Ref: KeRRA/16/1/LVSR/RWC150/RE-02/VOL.1/37A

## <u>UPGRADING TO BITUMEN STANDARDS AND PERFORMANCE BASED ROUTINE</u> MAINTENANCE OF CHOGORIA WERU-KIRIANI ROAD; CONTRACT NO.RWC 150.

## REF: UNDEFINED DRAINAGE AND BLOCKED ACCESS CULVERTS

KM.3+279 LHS

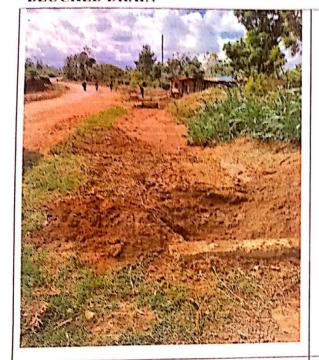
This office has noted with concern the high level of siltation on our drainage system due to the ongoing rains. This is in particular for the section at Km 3+200 L.H.S & R.H.S along the Marima-Kiriani road, where the culverts are completely silted and as a result, the water has overtopped the culverts and ended up in the adjacent residence making life unbearable for the occupants. (*Photos attached*)

Further to this, the drain before the culvert at Km 3+200 R.H.S is undefined resulting in rainwater crossing our road from the R.H.S to the L.H.S at that particular section.

- 1. To define the affected drains and channel the water to the culverts.
- 2. To open up all silted drains and blocked access culverts.
